#### Working Party on Lighting and Light-Signalling

### **Proposal for draft amendments to Regulation No. 70 (Rear-marking plates for heavy and long vehicles)**

#### **Submitted by the expert from the European Association of Automotive Suppliers\***

**Figure 3a**

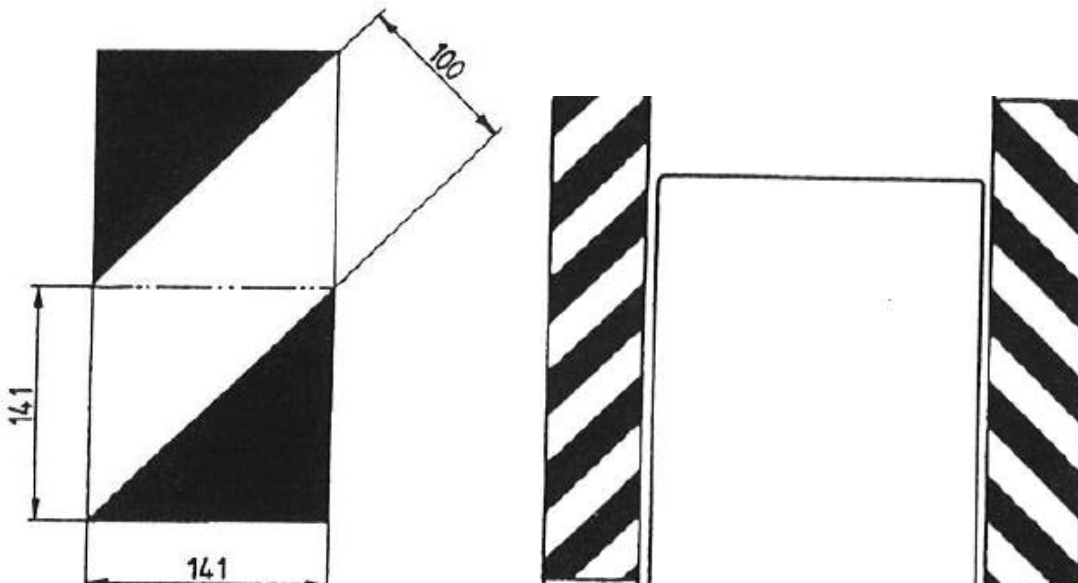
**Class 5 retro-reflective materials shall consist of red and white diagonal stripes each 100 mm wide, sloping outwards and downwards at 45°. The**

basic standard area is a square of 141 mm in length subdivided into a white half and a red half, which represents one standard area.

Prescribed shapes, patterns and dimensional features of Class 5 devices are illustrated in figure 3 of Annex 12 to this Regulation.

Annex 12, insert a new title after Figure 2 and insert new Figure 3:

**Figure 3b**  
**Example for a plate design**

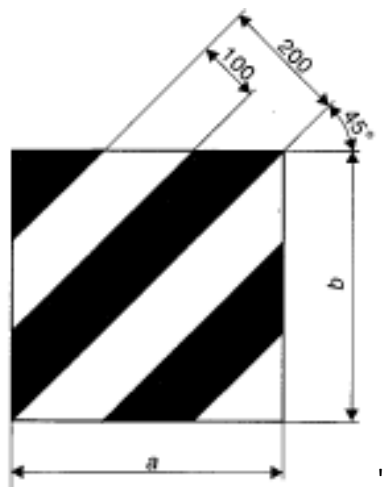
**Class 5 devices shall incorporate a minimum of nine standard areas as described in paragraph 3.4. below on large vehicles with available mounting space, but may be reduced to a minimum of four standard areas on vehicles with limited mounting space.**
